March 22, 2013

**RE: PETITION FOR MODIFICATION AND TRANSFER OF THE POWER PLANT SITE CERTIFICATION,
CEMEX CONSTRUCTION MATERIALS FLORIDA, LLC SOUTH CEMENT PLANT'S STEAM
ELECTRIC GENERATING PLANT (PA-82-17); AMENDMENT OF PETITION**

Text, Figure, and Appendix Modifications to the Petition for Modification and Transfer

FIGURE 2.3.7-1

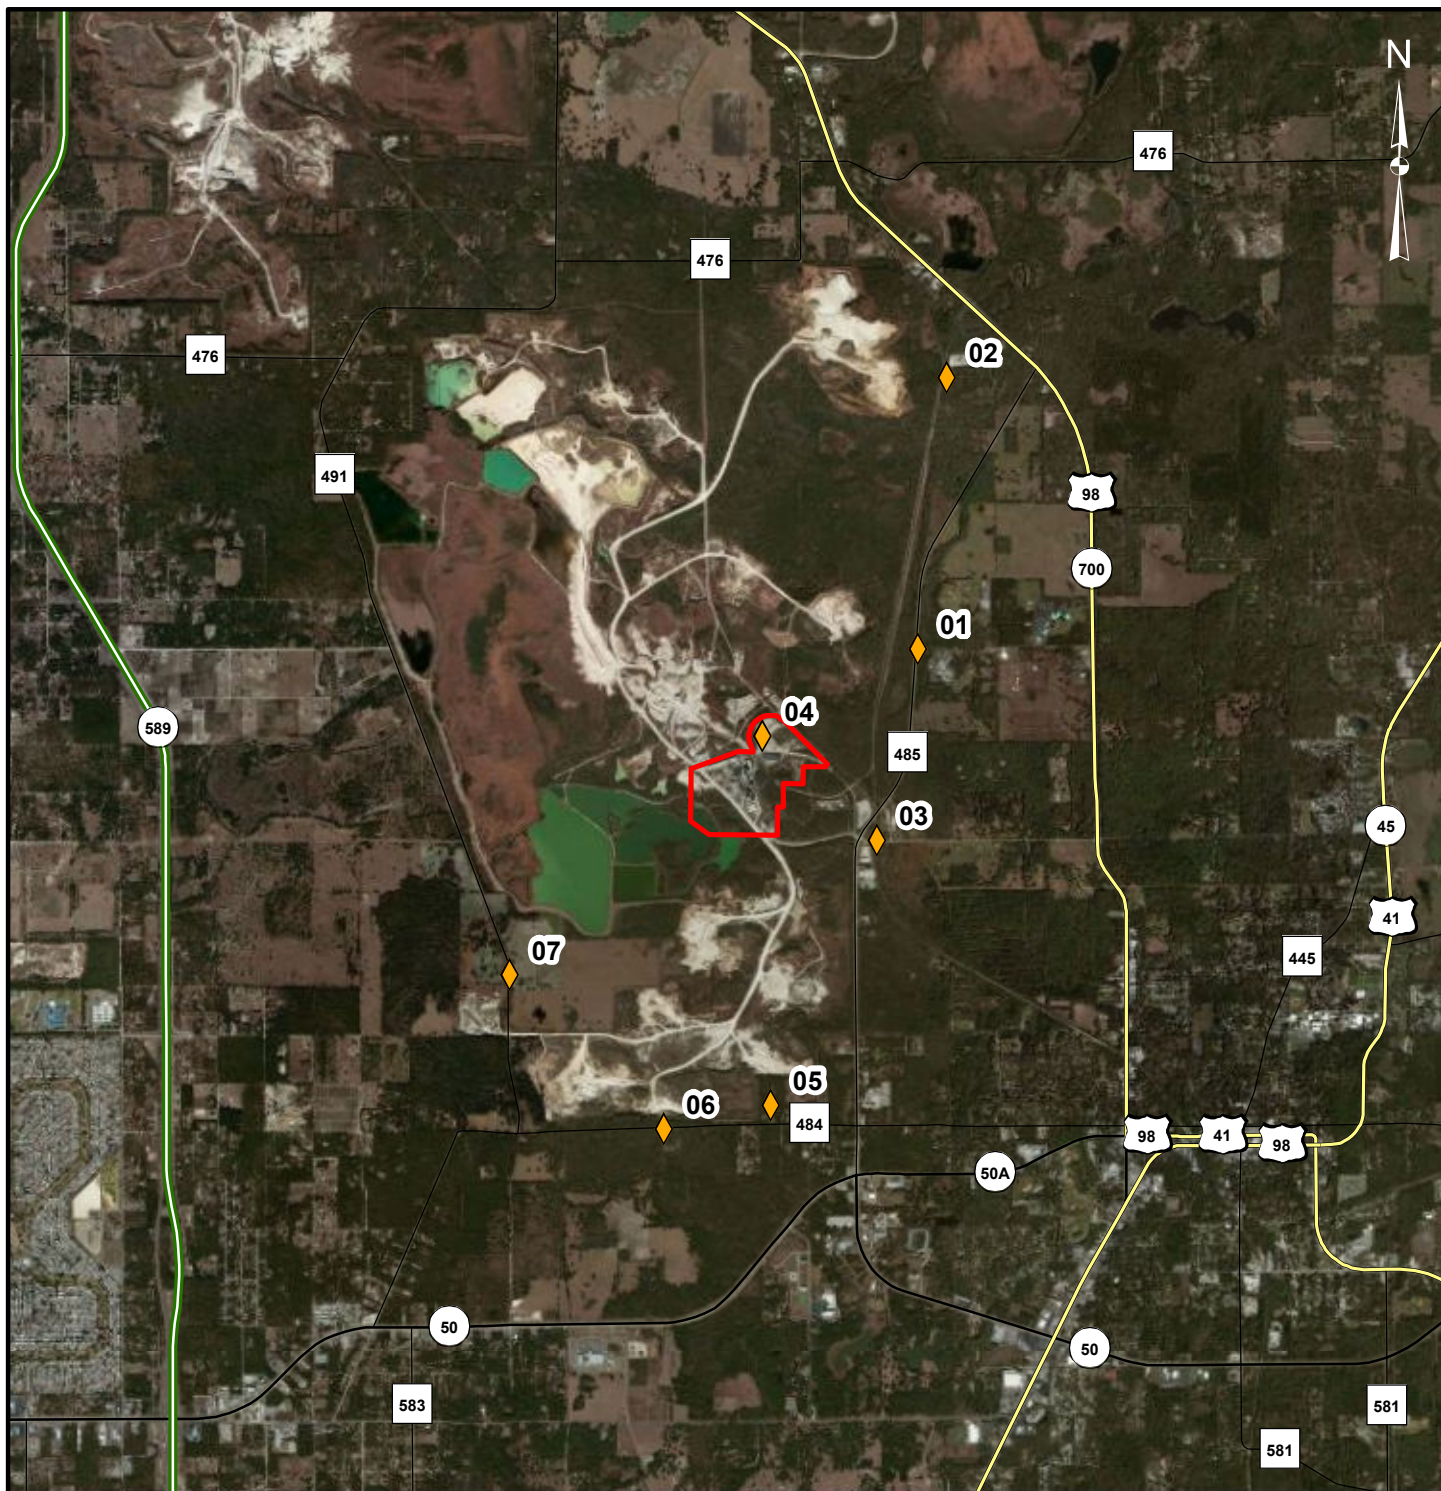
Figure 2.3.3-1	Proposed certified site boundary	Boundary and Site Acreage
Figure 2.3.3-2	Proposed certified site boundary	Boundary and Site Acreage
Figure 2.3.4-1	Proposed certified site boundary	Boundary and Site Acreage
Figure 2.3.5-1	Proposed certified site boundary	Boundary and Site Acreage
Figure 2.3.5-2	Proposed certified site boundary	Boundary and Site Acreage

**ENVIRONMENTAL RESOURCE PERMIT
FIGURE 1
REVISED PROPOSED PROJECT IMPACTS**

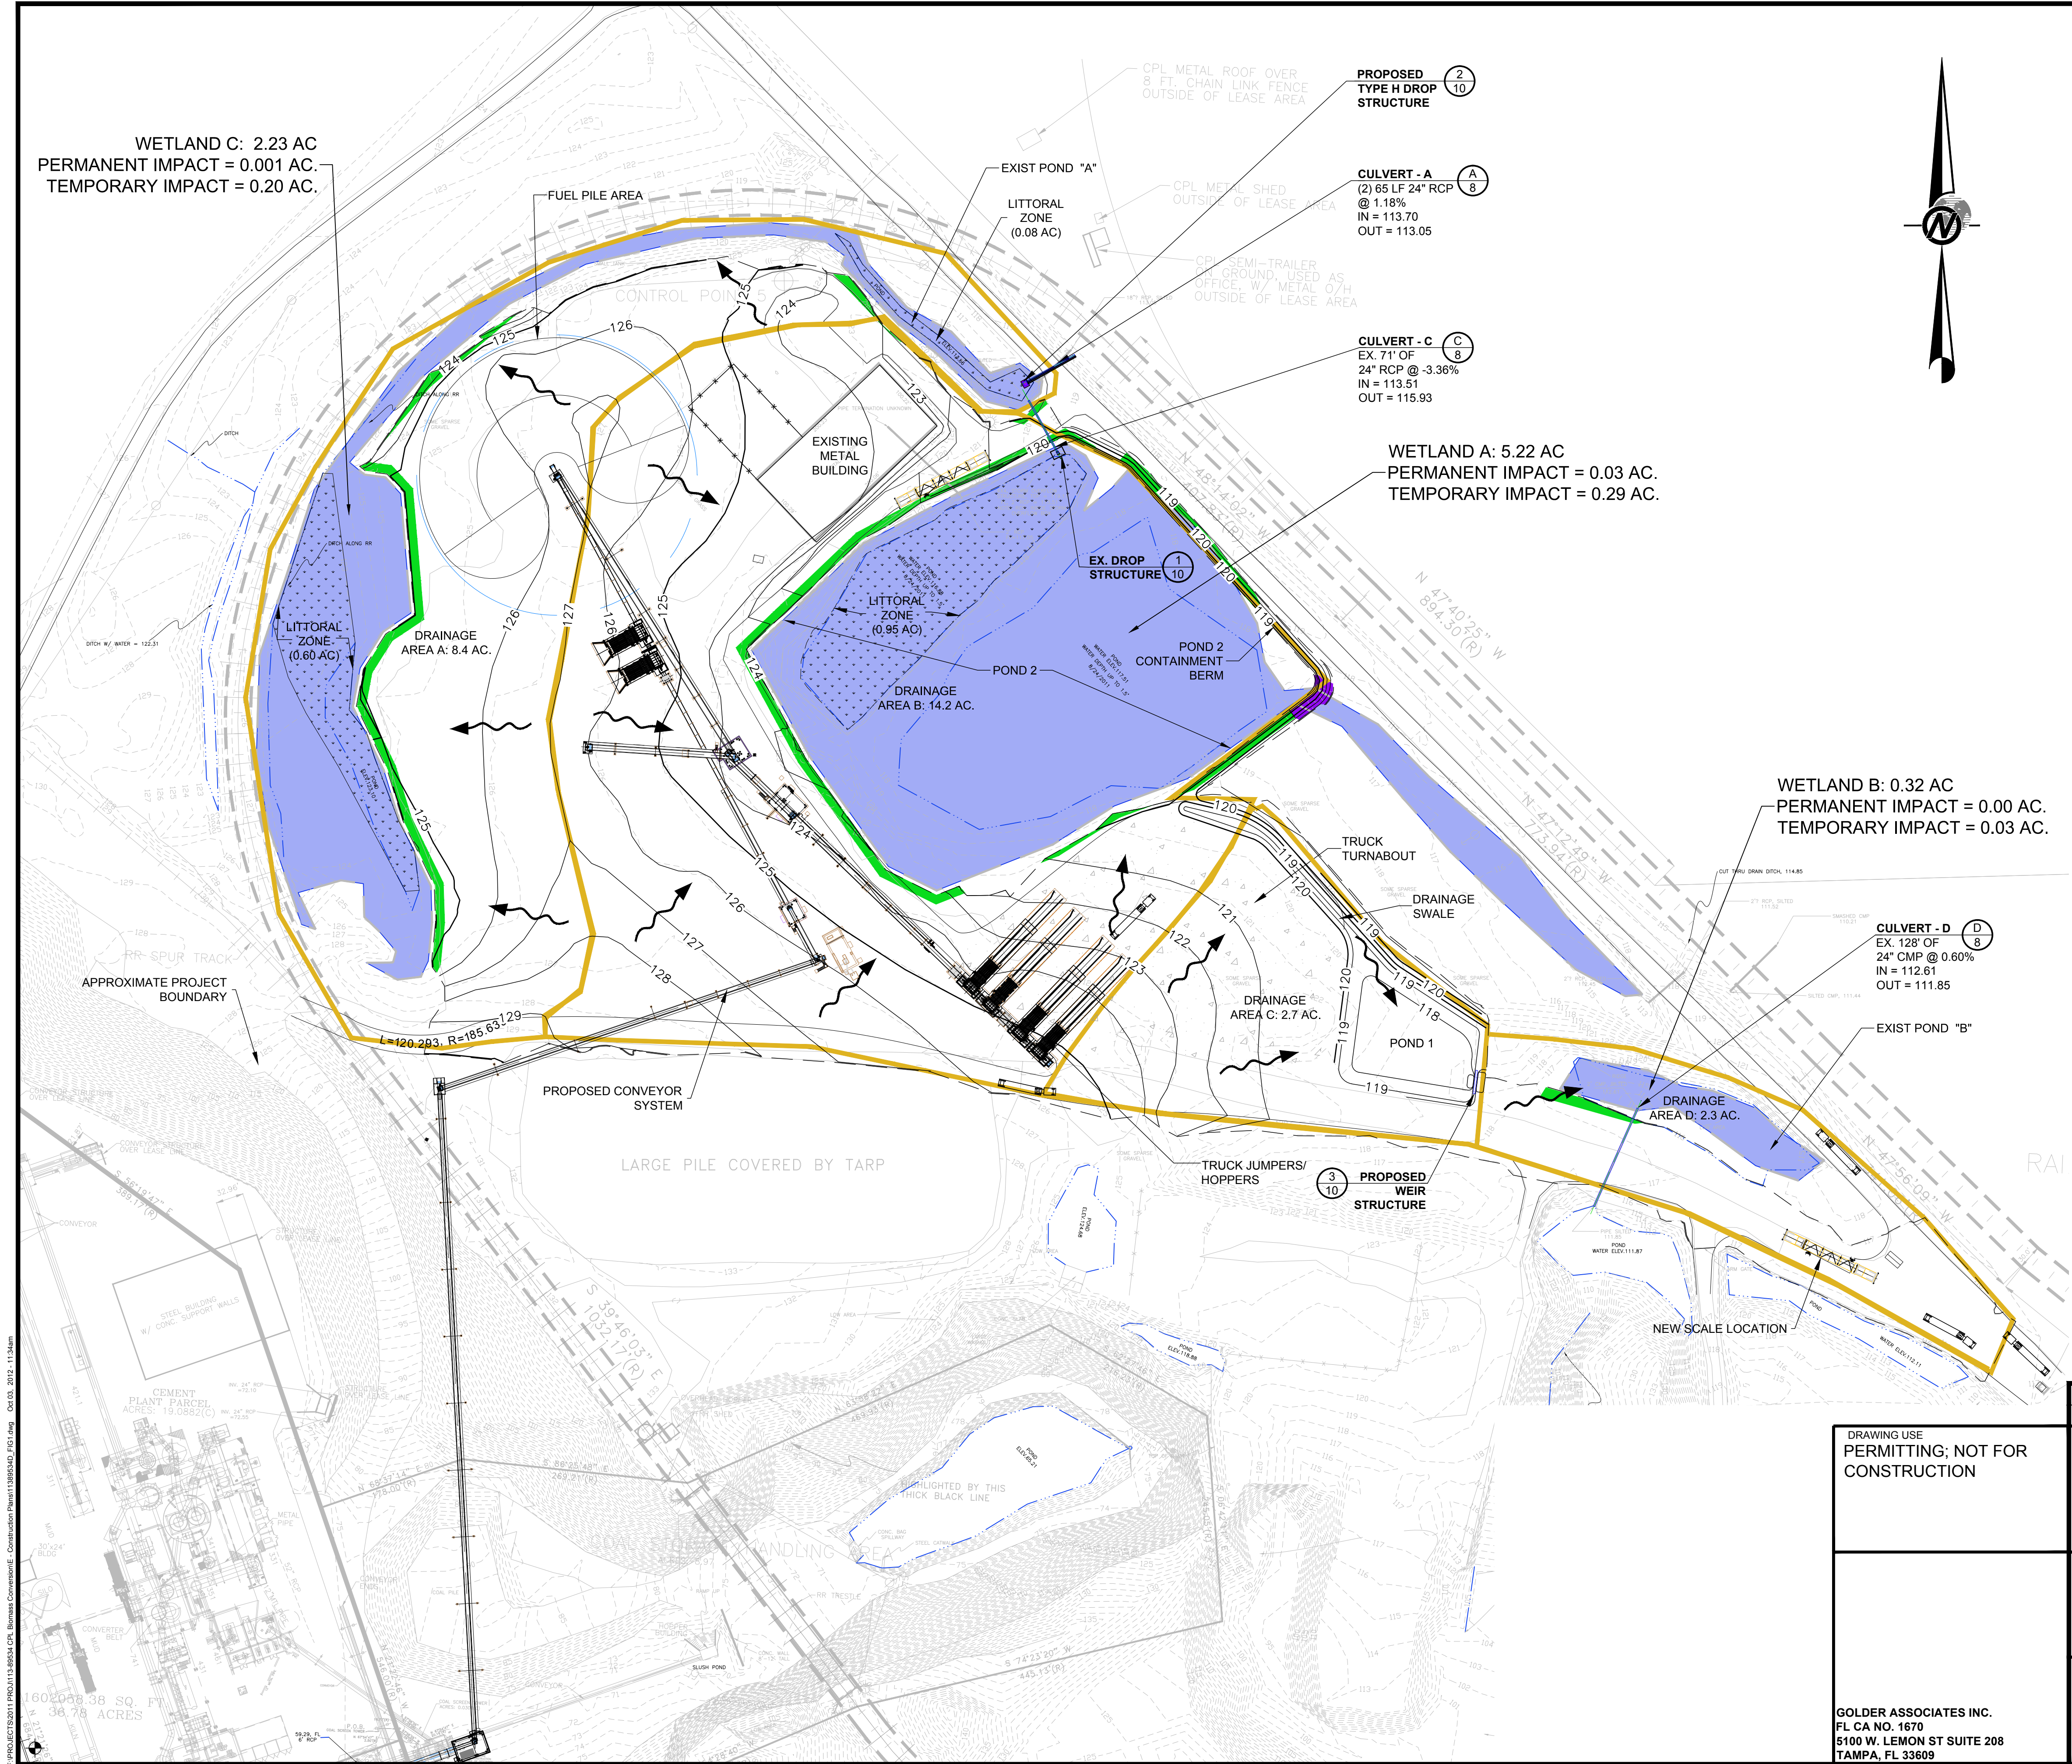
Please note that Figure 1, Proposed Project Impacts, is being provided herein to reflect the updated earthworks quantities shown on the construction plans. In addition, the construction plan sheets provided with this submittal include 7 of the 12 sheets that have been updated to depict the approximate location of the modified certified site boundary and the corresponding revised acreages associated with the project.

PROJECT		FLORIDA POWER DEVELOPMENT, LLC BIOMASS CONVERSION	
TITLE		POST DEVELOPMENT DRAINAGE PLAN

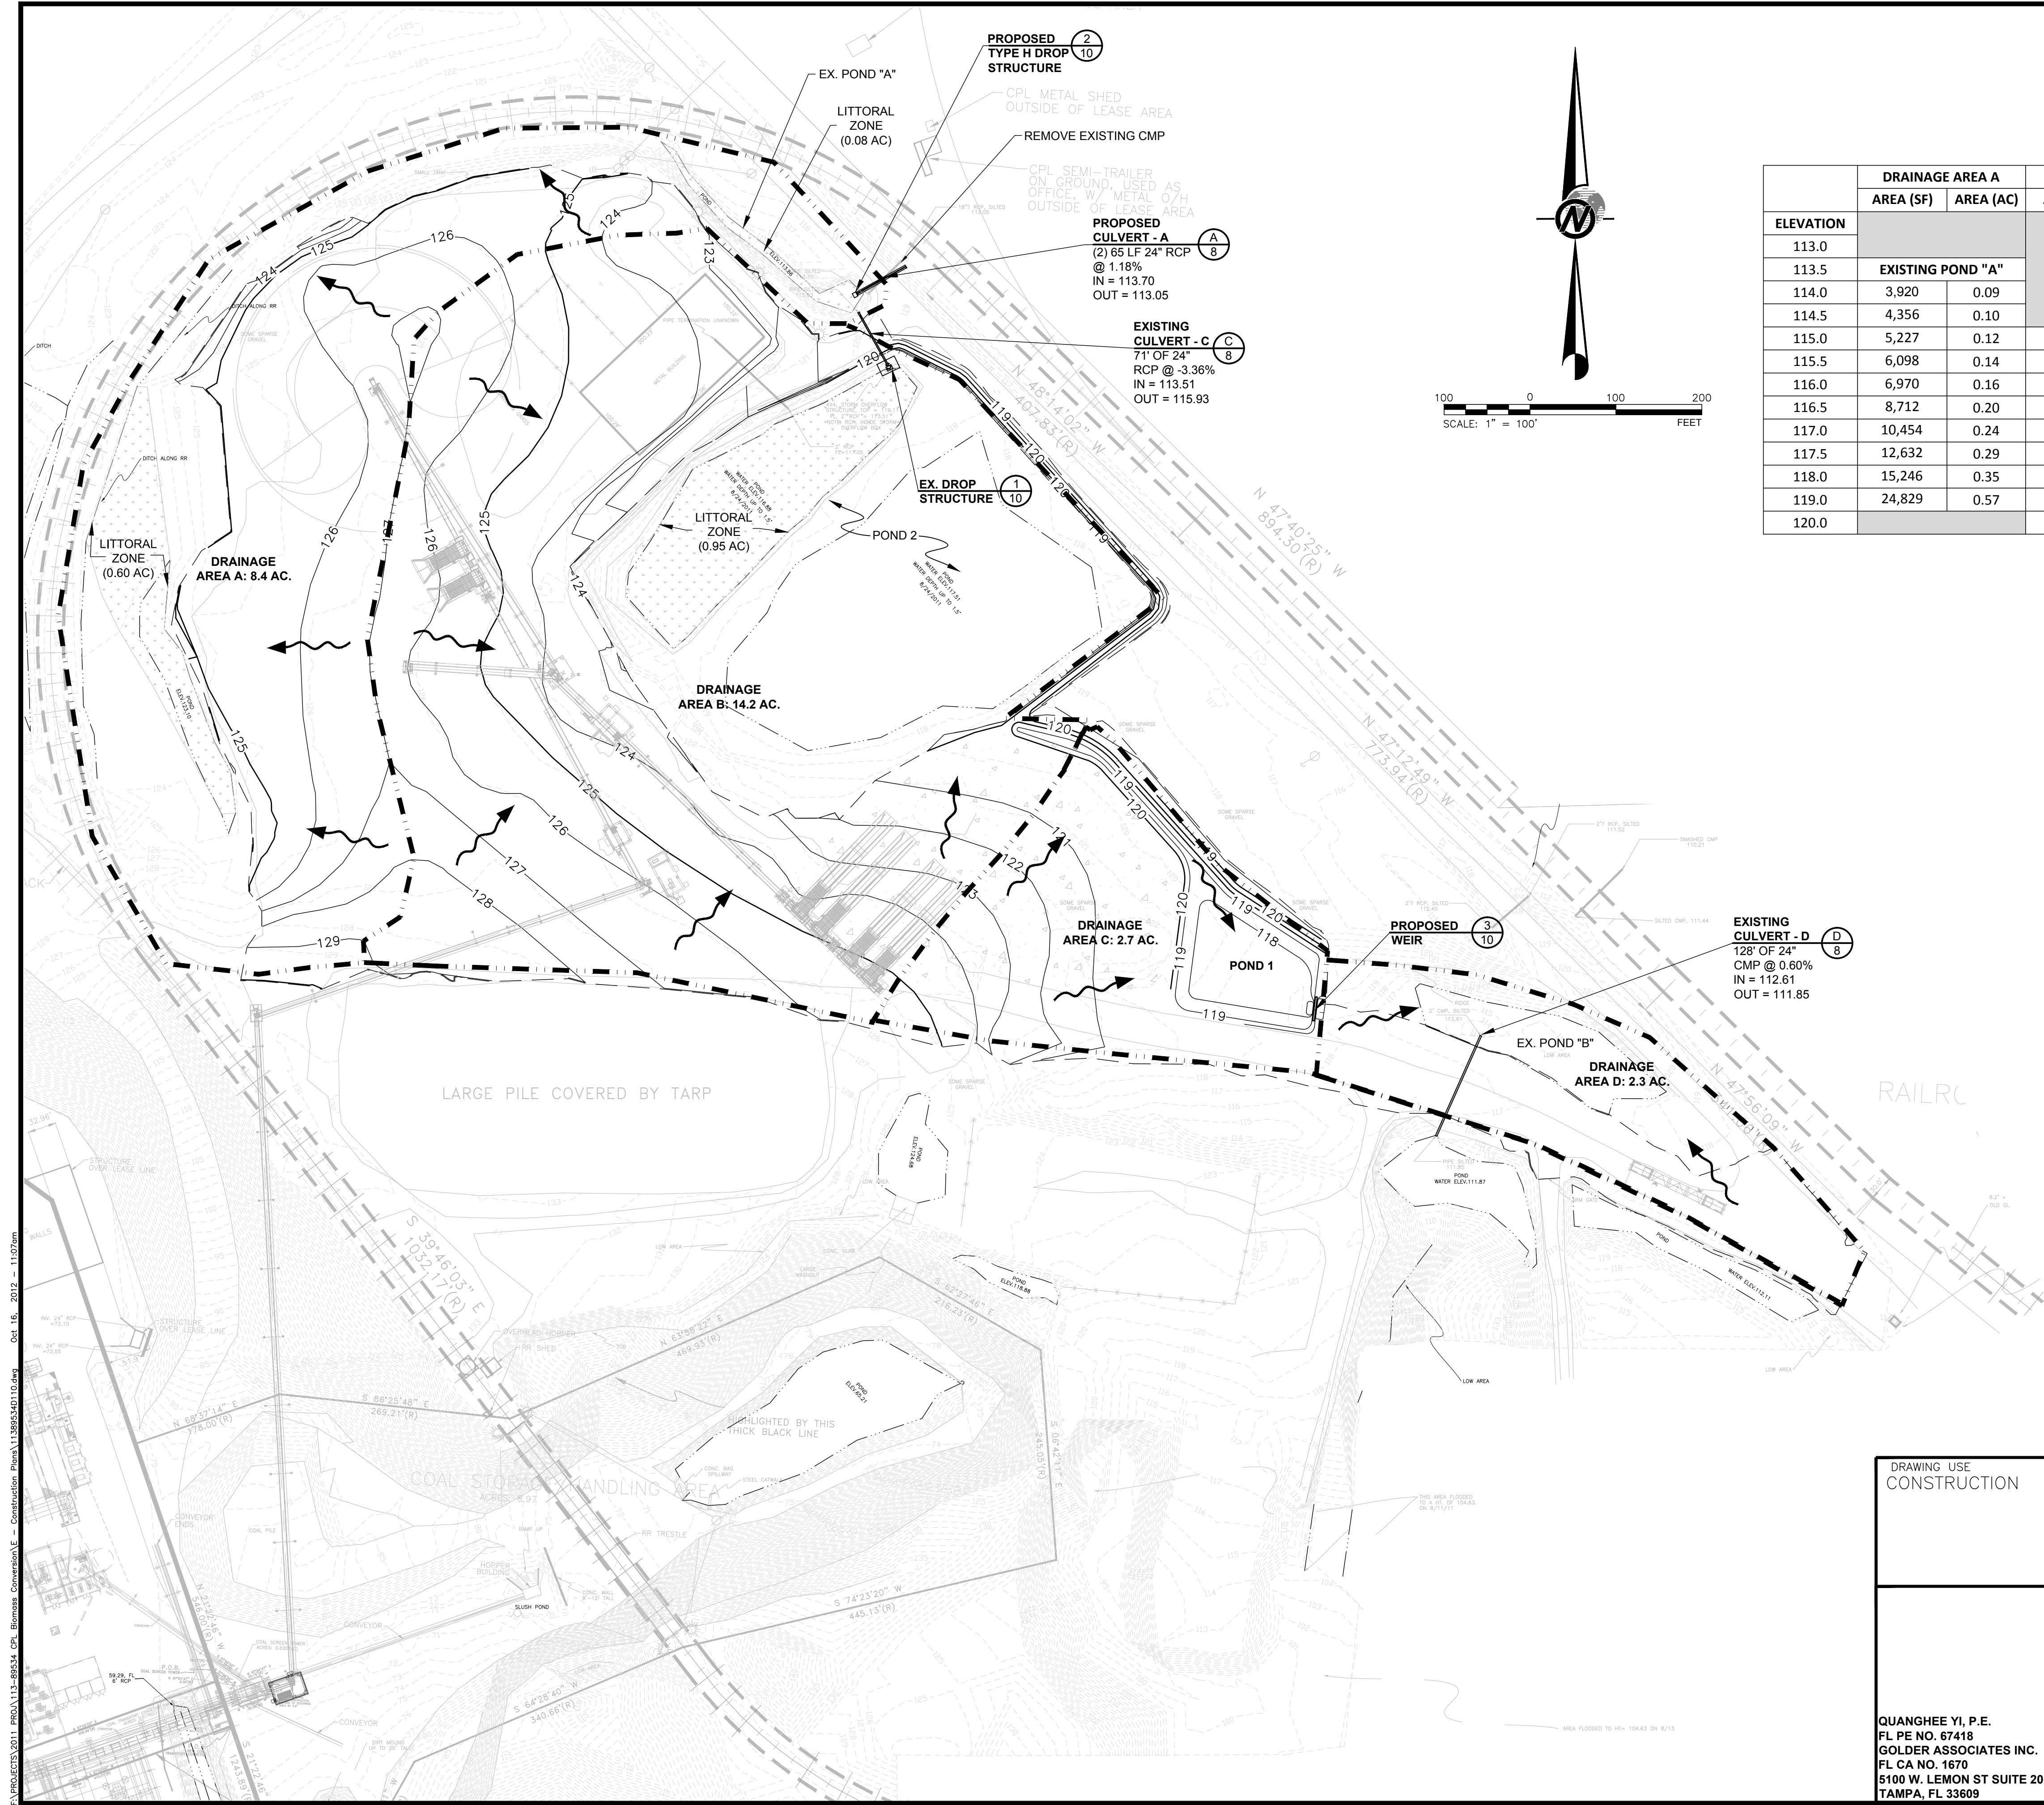
Sheet 06 Post Development Drainage Plan	Boundary and Site Acreage
	Sheet 07 Post Development Drainage Plan	Boundary and Site Acreage
	Sheet 12 Traffic Plan	Boundary and Site Acreage
	Attachment D- Topography and Wetland Survey	Boundary and Site Acreage
Appendix 8.7.6	Site Survey	Boundary and Site Acreage

2	9/21/12		FDEP INFORMAL COMMENTS	BML	EKN	MHS
1	9/5/12		GRADING AND STRUCTURAL CHANGES PER CLIENT REQUEST	BML	EKN	MHS
REV	DATE	DES	REVISION DESCRIPTION	CADD	CHK	RVW
PROJECT						
FLORIDA POWER DEVELOPMENT, LLC BIOMASS CONVERSION						
TITLE						
PROPOSED SITE PLAN						
			PROJECT No. 113-89534	FILE No. 11389534D104		
DESIGN	MHS	9/16/11	SCALE	As Shown	REV.	2
CADD	JCB	9/16/11				
CHECK	MHS	9/16/11				
REVIEW	KHE	9/16/11
